Re: 484-PA-2017
1-UP-2018
City of Scottsdale Fire Station 603

RE: 1-UP-2018 and 2-DR-2018
City of Scottsdale Fire Station 603

City of Scottsdale MUMSP Review Comments & Responses

project: **City of Scottsdale, Fire Station 603 / Case Number: 1-UP-2018 and 2-DR-2018**
 date: 04.09.18

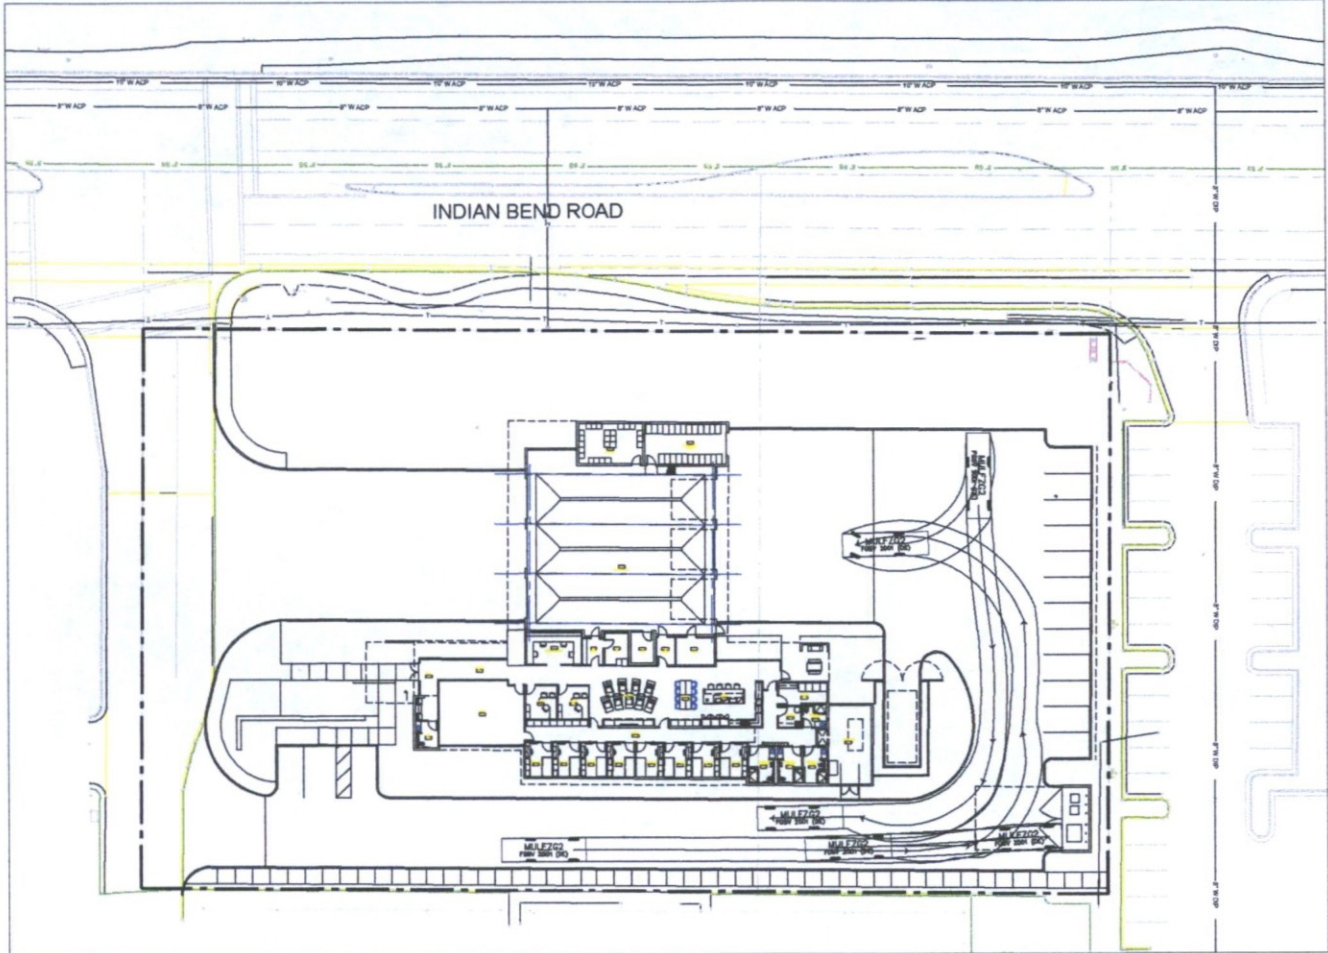
David, we reviewed this and would ask that the enclosure be moved 5 to 10 feet further south. Doing so would increase our exit turning radius and would allow more room for thru traffic.

We currently have limited ingress/egress access to Indian Bend.

Attached is a graphic exhibit illustrating a proposed refuse enclosure location and the resultant truck maneuvering approach for which we would appreciate your review.

Good news re: 603 site – the refuse pickup works without needing access to the east. I spoke to Frank Moreno this morning. The following comments had been sent to Plan Review section, but I was not copied until now.
